# ESTELLE SUPPORTIVE HOUSING DESIGN REVIEW

3501 RAINIER AVE SOUTH,  
SEATTLE, WA 98144  
DPD PROJECT # 3020850  
RECOMMENDATION MEETING  
JUNE 14, 2016

EDG RESPONSE

EARLY DESIGN GUIDANCE OCTOBER 27, 2015

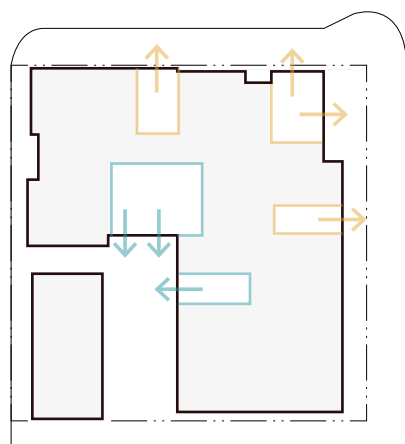
**C.** The Board stated that the proposed double height corner lounge should be expressed on the façade. (DC2.A.1, CS2.C.1)

**Response:**

- A double-height ground level space is no longer a part of the building program. Instead, offices for residential staff occur at Level 2 where a prominent recess frames the main entry and carries vertically at the stair tower. The recess, material, and color change is repeated along the rear yard west façade to break up the building massing.

### 3. PARKING & AMENITY SPACE:

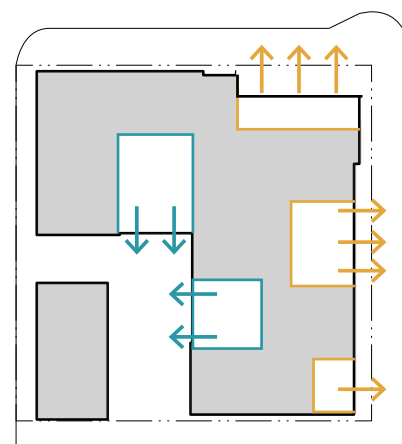
The Board discussed the parking structure at length and noted that while it helped to mitigate the privacy and noise impacts from the outdoor amenity space and provided a scale transition to the adjacent single family zone, it should be better integrated into the building and site design.

**A.** The Board directed the applicant to explore alternative configurations for the parking including physically attaching it via breezeway or shifting it towards the north to attach to the building, integrating it into the ground floor of the building, or rotating it to create more of a courtyard. For the next meeting, the Applicant should provide additional study on the possible parking configurations. (DC1.B.1, DC1.C.2&3)

**Response:**

- Per the direction from the Board, alternative configurations of the garage were explored (see page 14 and 15 for further explanation). The configuration as shown best meets the needs of the client by providing the required security for the site, keeping hidden spaces to a minimum, maximizing usable courtyard area, and giving a strong residential presence along the alley.

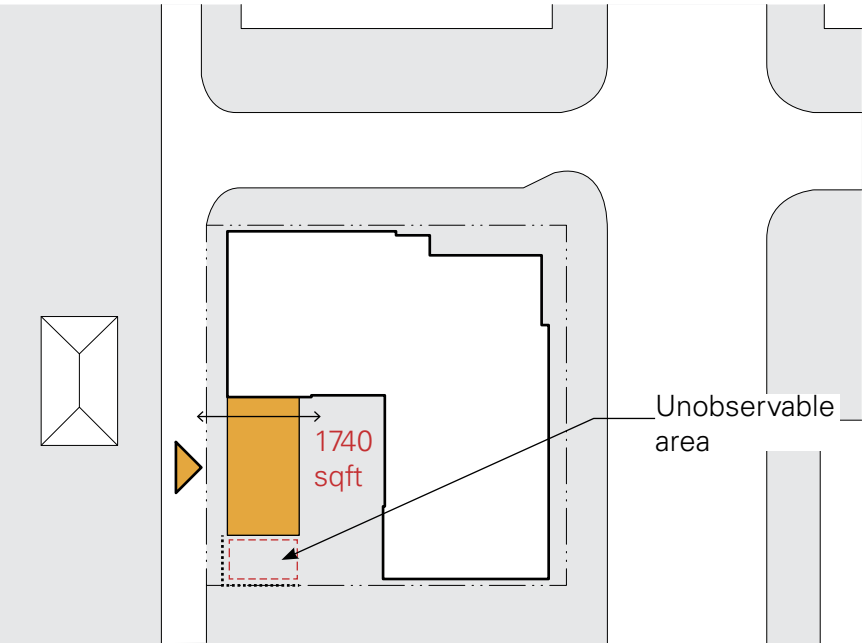
**D.** The Board directed the applicant to explore the possibility of amenity space on the roof of the garage. (DC1.B.1, DC1.C.2&3)

**Response:**

- An amenity space above the garage was not provided due to Owner concerns regarding tenant safety. The green roof, however, provides a visually pleasing view for tenants and helps create a residential presence on the alley.
